# Inspection of Automatic Sprinkler System

Fire Suppression Solutions - Automould - ELIDZ -  
East London

UNC.8484

Automould (New warehouse  
extension)

Photo 40

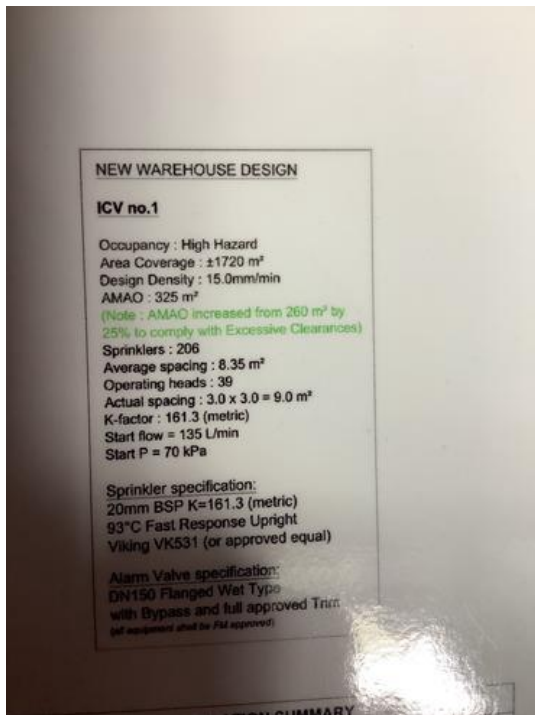
No

A block plan must be provided with the following indicated thereon:

Particulars of the water supplies.

The occupancy of each building.

The hazard class of the system.

The extent of the protection.

The calculated flow and pressure requirement of the system.

A cross-section of the full height of the building or buildings indicating the height of the highest sprinkler with respect to a stated datum level.

The flows and pressures for the remote and favorable areas of operation recorded on the block plans must reflect the maximum pressure (Pmax) and the maximum flow (Qmax) respectively.
